Closing Statement

Do the adverse impacts of the proposed scheme outweigh its benefits? [[PA2008, s104\(7\)](#)]

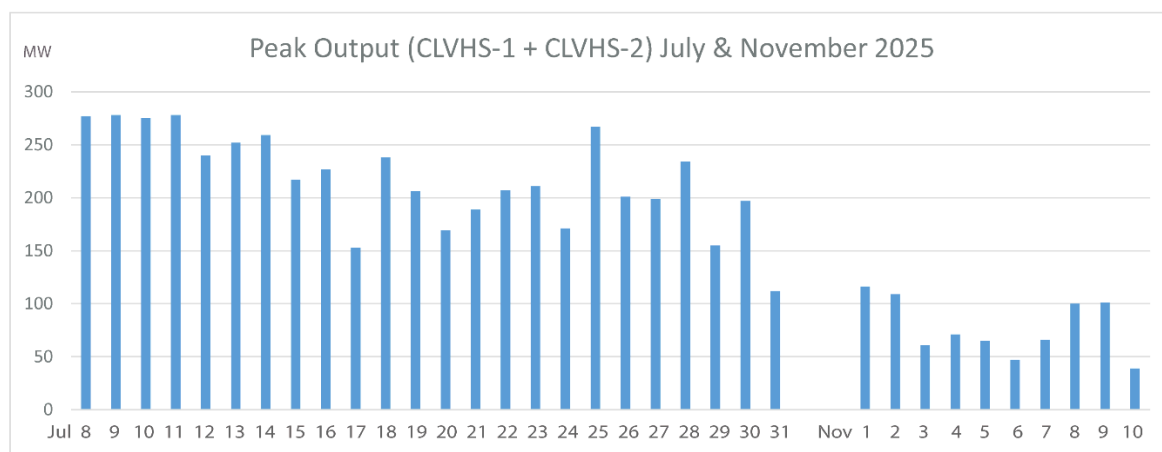
The Cleve Hill connection at the NG substation was configured to full power on 8th July. This was coincidentally the day of peak output for UK solar PV in 2025, thus opening a window onto Cleve Hill's real-world performance.

The Applicant promised unsubsidised electricity with a peak “in excess of 350 MW.”

The ExA predicted an output of between 300 and 400 MW [[ExA Recommendation](#), 5.3.13].

Based on school Physics and the solar incidence angle to east-west panels in the UK, one would expect the peaks to be below 300 MW [[REP1-157](#), page 5 *Looking forward*].

Peak output exceeded 250 MW on six days over this study period.⁴
